COMMISSION REGULATION (EU) 2019/318

amending Regulation (EU) 2017/2400 and Directive 2007/46/EC of the European Parliament and of the Council as regards the determination of the CO₂ emissions and fuel consumption of heavy-duty vehicles**(Text with EEA relevance)**

‘1.5. Example of the certification mark

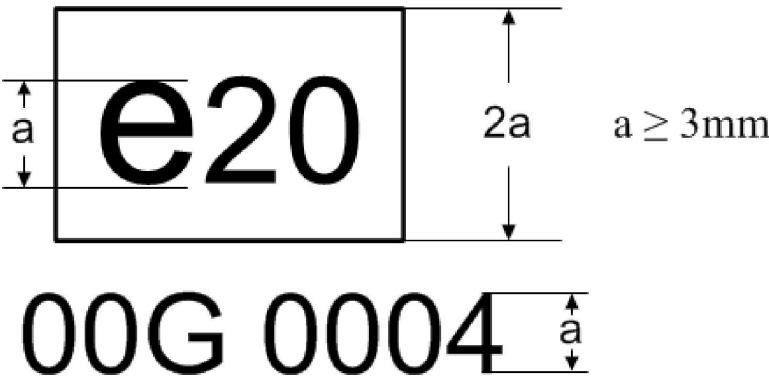
(c) point 1.5 is replaced by the following:

The above certification mark affixed to a transmission, torque converter (TC), other torque transferring component (OTTC) or additional driveline component (ADC) shows that the type concerned has been certified in Poland (e20), pursuant to this Regulation. The first two digits (00) are indicating the sequence number assigned to the latest technical amendment to this Regulation. The following digit indicates that the certification was granted for a transmission (G). The last four digits (0004) are those allocated by the approval authority to the transmission, as the base approval number.’;

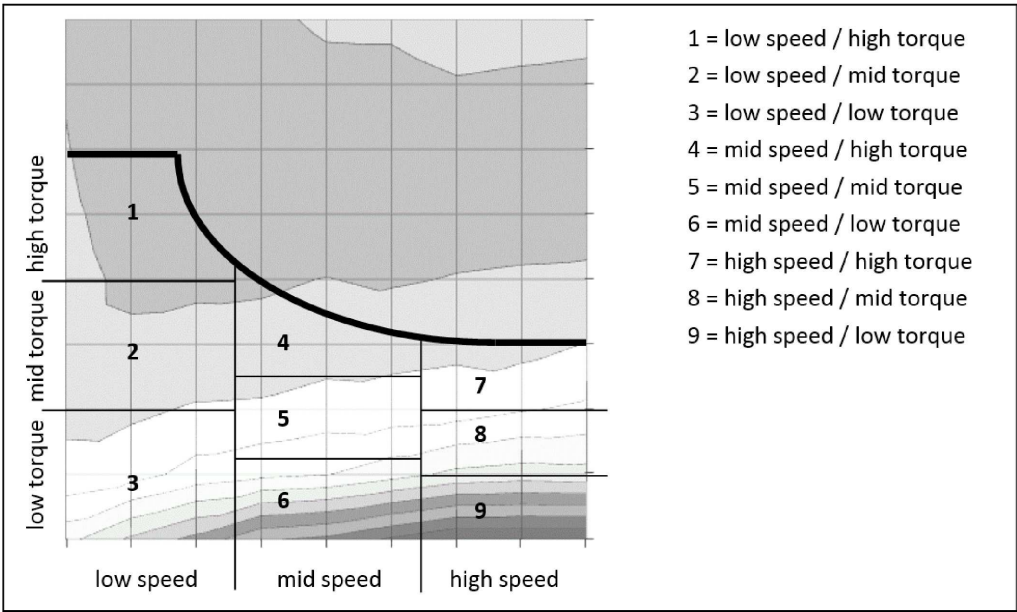
- (6) point 4.4.8.5 is replaced by the following:
‘4.4.8.5. In case of a tandem axle, the combined torque loss map for both axles shall be calculated out of the test results for the single axles at the input side. The input torques shall also be added.

$T_{loss,rep,tdm} = T_{loss,rep,1} + T_{loss,rep,2}$

$T_{in,tdm} = T_{in,1} + T_{in,2}$ ’;
